D206-667-107BL
Job Sheet 166582

Part Name: Fwd Crosstube - Mid Height 206L / L1 / L3 / L4, Blue

A	NEW ISSUE	CP	10.11.23
REV.	DESCRIPTION	BY	DATE
DESIGN	<i>97</i>	DART AEROSPACE LTD HAWKESBURY, ONTARIO, CANADA	
DRAWN	<i>97</i>		
CHECKED	<i>13</i>	DRAWING NO.	REV. A
MFG. APPR.	<i>13</i>	D206-667-147	SHEET 1 OF 4
APPROVED	<i>13</i>	TITLE	SCALE
DE APPR.	<i>13</i>	CROSSTUBE ASS'Y (206L MID FWD)	NTS
DATE	10.12.23	COPYRIGHT © 2010 BY DART AEROSPACE LTD THIS DOCUMENT IS PRIVATE AND CONFIDENTIAL AND IS SUPPLIED ON THE EXPRESS CONDITION THAT IT IS NOT TO BE USED FOR ANY PURPOSES OR FOR ANY COMMERCIAL OR INDUSTRIAL PURPOSES WITHOUT WRITTEN PERMISSION FROM DART AEROSPACE LTD.

DRAWING NO. D206-667-147	TITLE CROSSTUBE ASS'Y (206L MID FWD)	REV. A	DART AEROSPACE LTD ENGINEERING ORDER		D.E.O. NO. D206-667-147-A-1	SHEET NO. SHEET 1 OF 1	SCALE NTS
DRAWN <i>q</i>	CHECKED <i>ASS</i>	MFG. APPR. <i>JB</i>	APPROVED <i>MD</i>		DE APPR. <i>MD</i>		
DATE 11.07.15	DATE 11.07.20	DATE 11.07.21	DATE 11/07/21		DATE 11.07.21

DETAIL P
BONDING STRAP INSTALLATION 2 PL

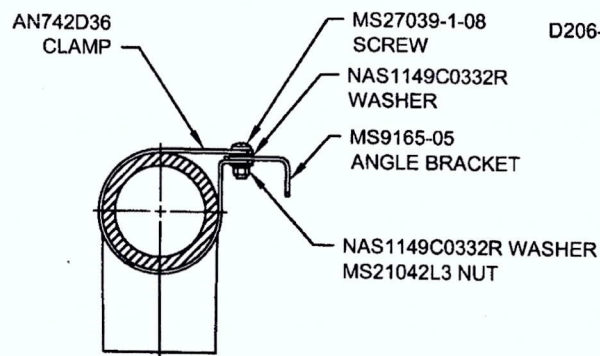
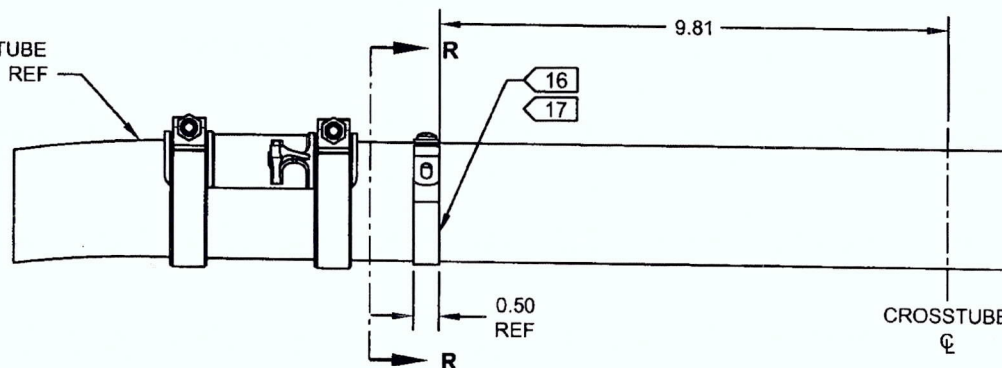
ADD ELECTRICAL GROUNDING STRAP

ITEM	QTY -147	PART NUMBER	DESCRIPTION
1	X	D206-667-147	CROSSTUBE ASSEMBLY (206L MID FWD)
10	2	AN742D36	CLAMP
11	2	MS9165-05	ANGLE BRACKET
12	2	MS21042L3	NUT (OR MS21042-3)
13	2	MS27039-1-08	SCREW
14	4	NAS1149C0332R	WASHER (OR AN960C10L)

- 16) MASK AREA UNDER CLAMP PRIOR TO PAINTING
17) SEAL EDGES WHERE AN742D36 CLAMP MEETS WITH THE CROSSTUBE USING SIKAFLEX-241/-291 OR MIL-S-8802 CLASS B2 OR PROSEAL 890 SEALANT
18) PERFORM RESISTANCE CHECK TO ENSURE MAX RESISTANCE IS 10 MILLIOHMS
